Re: ENERGY STAR Room Air Conditioners
Draft 3 Version 3.0 Specification Document

On behalf of the Association of Home Appliance Manufacturers (AHAM), I would like to provide our comments on the ENERGY STAR Room Air Conditioners Draft 3 Version 3.0 Specification Document.

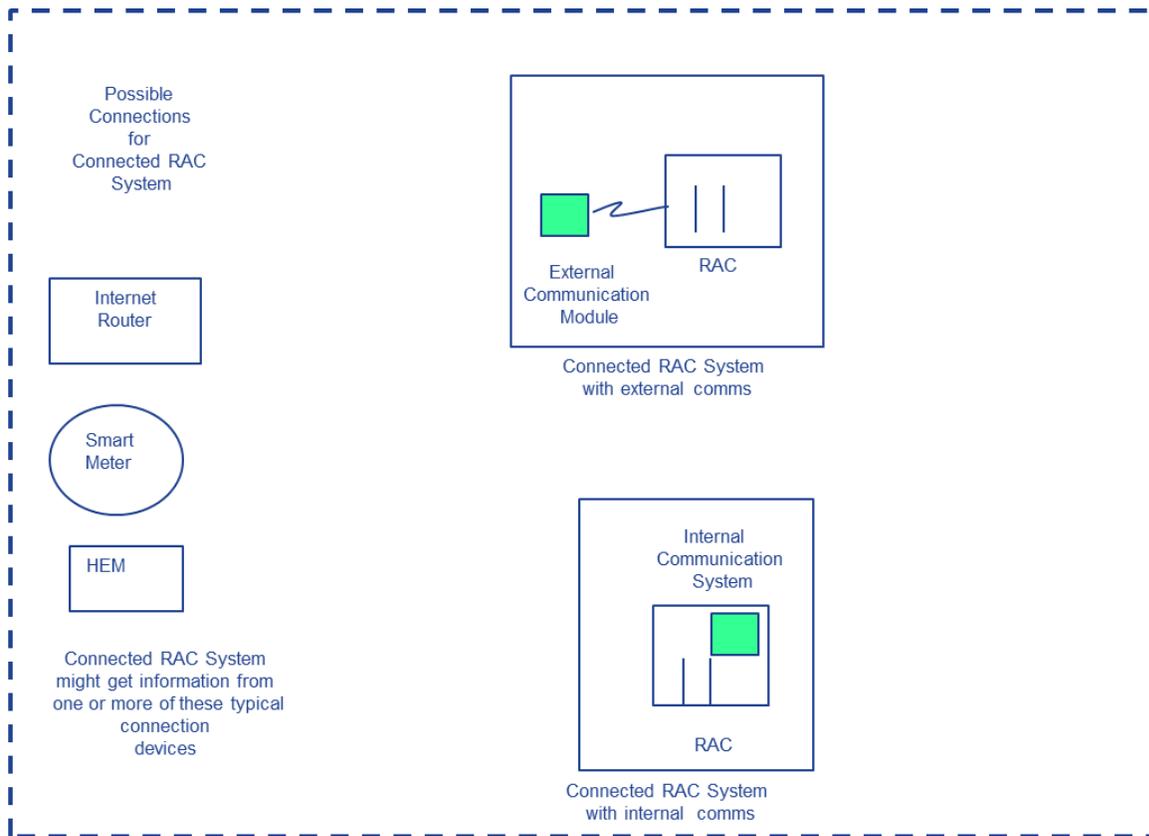
The first paragraph provides an overview; however, additional language is needed for clarification on the discussion for the system under consideration. AHAM proposes to include the following in order to define the system boundaries: “the connected room air conditioner is an appliance that provides all the necessary hardware and software for communications”. For further clarification, below is a diagram to illustrate the system boundaries.
